**RCF Modification sheet to RDSO Specification no.RDSO/PE/SPEC/AC/0200-2020  
for LHB GS AC Coaches**

The RCF Annexure is being issued to incorporate the modifications required in the RDSO specification no RDSO/PE/SPEC/AC/0200, Rev – 0 for Set of Electrical Panels for LHB EOG/HOG Garib Rath type AC Coaches On Indian Railways to make it compatible with LHB EOG GS Coaches In reference to supply of the above panel for LGS AC coaches following modifications may be carried out:

EDML-187	NIL	18.06.22				Page 1 of 3
Doc. No.	Rev	Date	SSE/CAD	SEE/D&D	DyCEE/D&D	Page

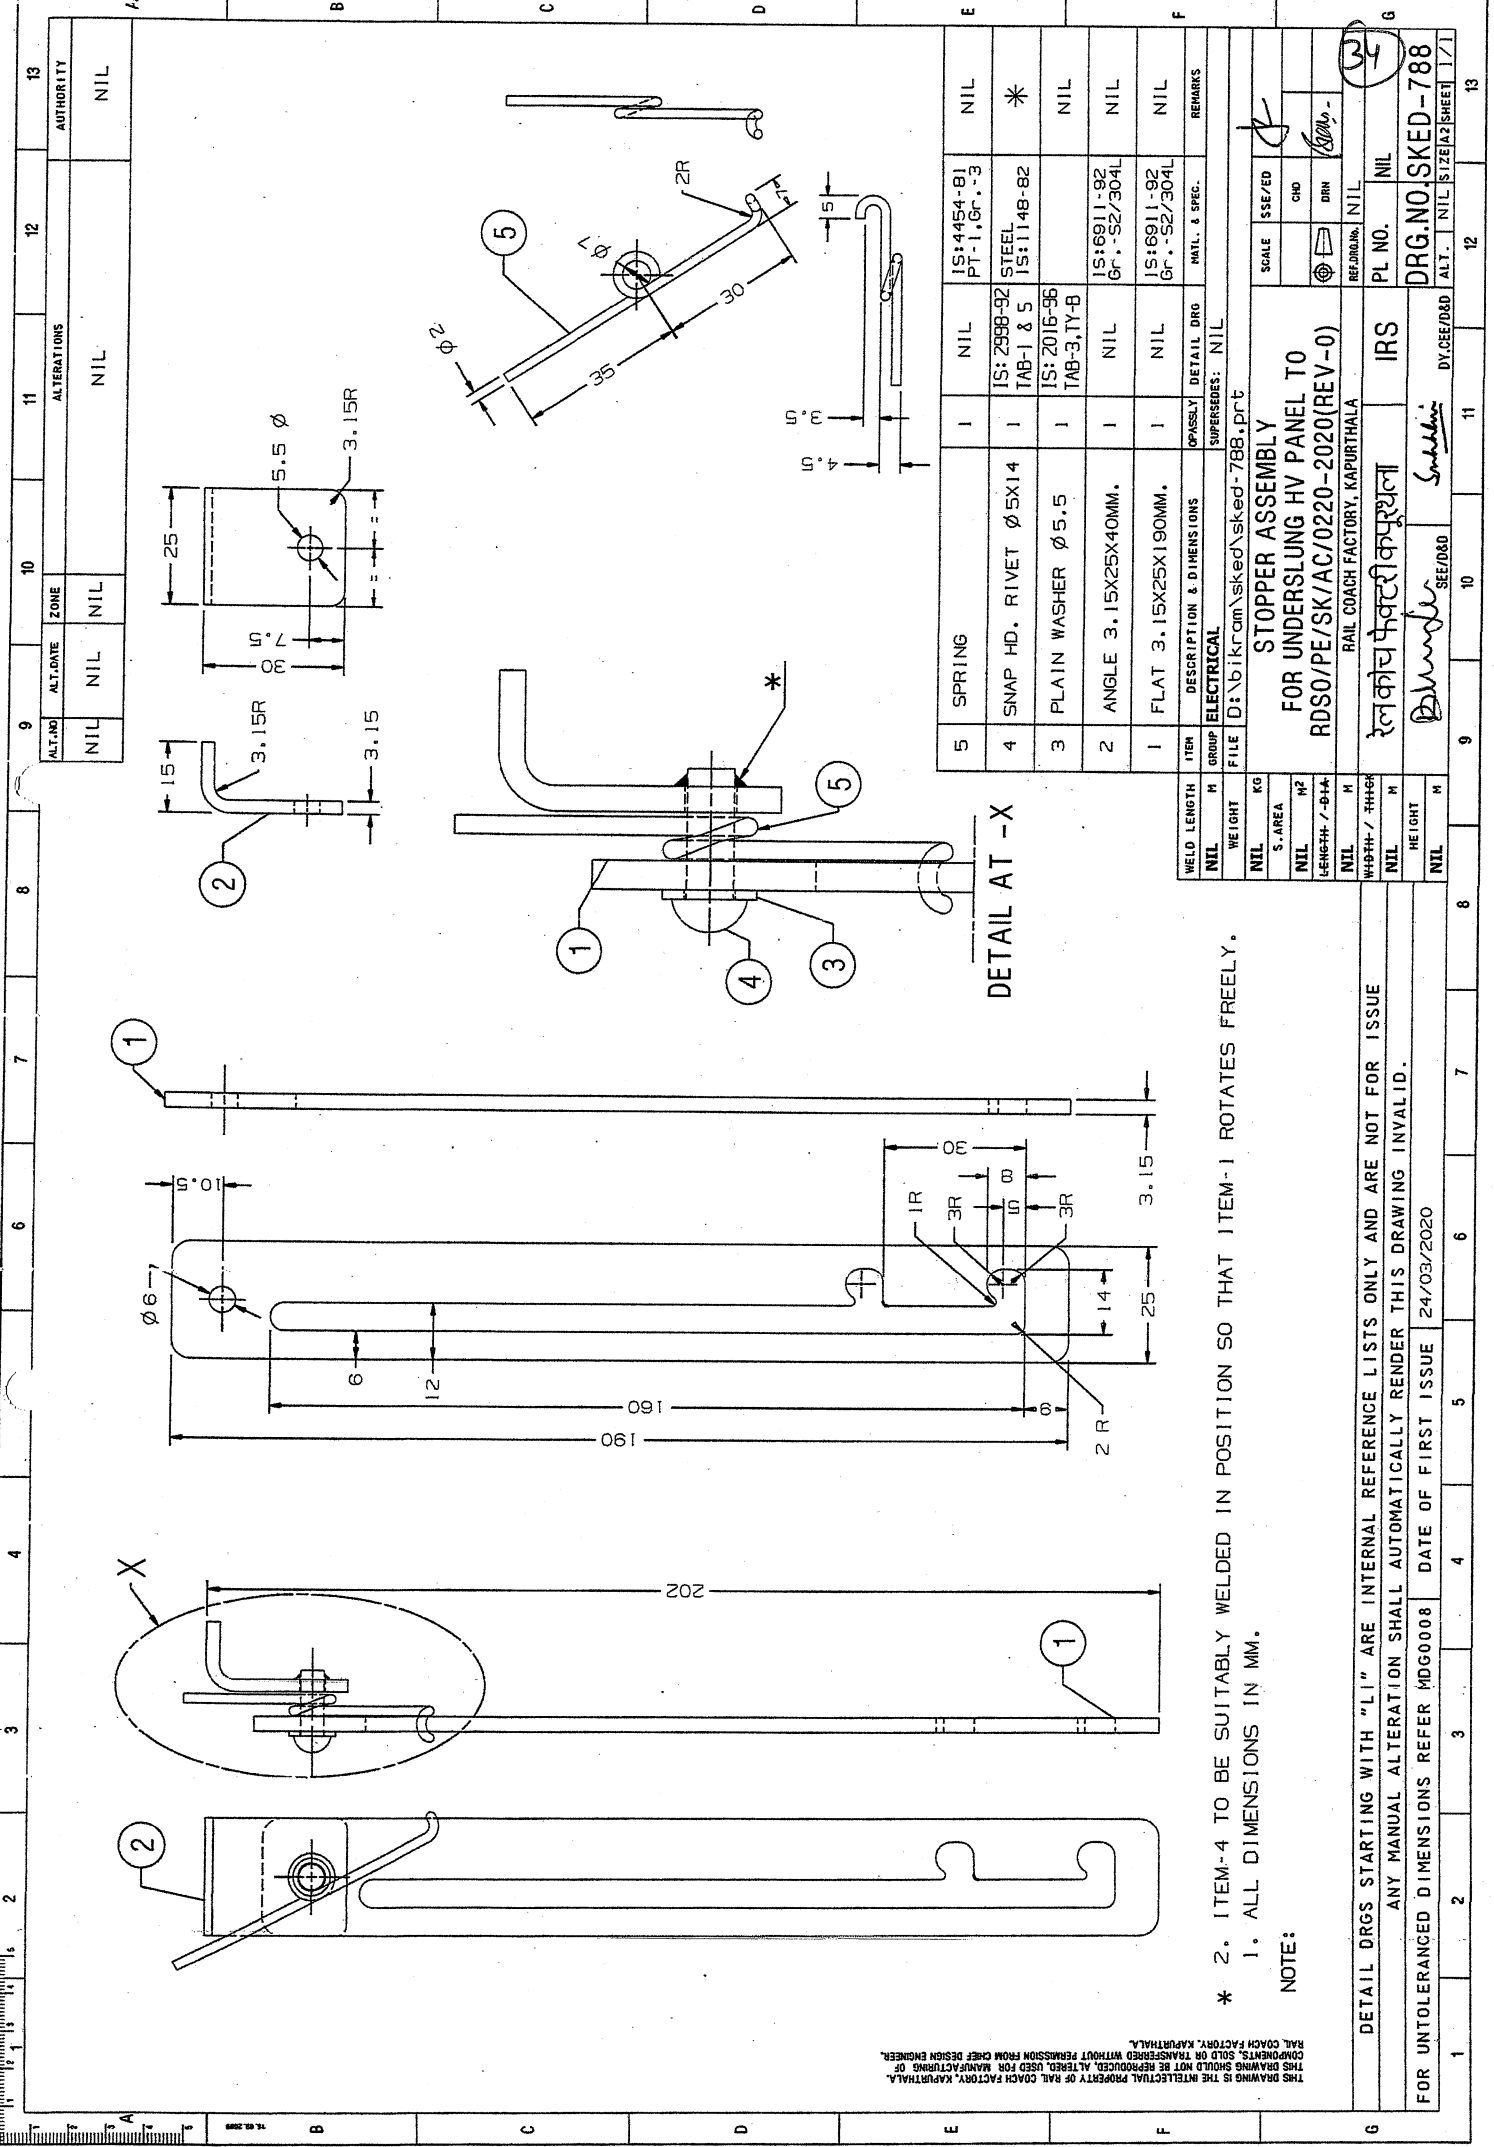
- F) Ref-General wiring diagram for Power and Control Circuits to RDSO/PE/SK/AC/0206-2019 ( Rev-0) sheet 46 of 48 :- Wago connector terminals for the pantry equipment no 282 to 285 and 289 to 297 deleted
- G) Ref-Door complete-Right to RDSO/PE/SK/AC/0219-2020 ( Rev-0) sheet 3 of 5.-The physical location of the test lamp push button S1S05 and light Push Button ON S1S08 on the front door may be interchanged so that the light push button ON and OFF are adjacent to each other.
- H) Mounting brackets and stopper assembly for HV Panel to RDSO/PE/SK/AC/0220-2020 (Rev – 0) shall be as per SKED787 and SKED788 respectively.

2. STOPPER ASSEMBLY SHALL BE PROVIDED ON COVERS AS INDICATED IN DETAIL-L. THE STOPPER ASSEMBLY SHALL BE SUCH THAT COVERS CAN BE OPENED AT 70 DEG. & 90 DEG. NOTE:-
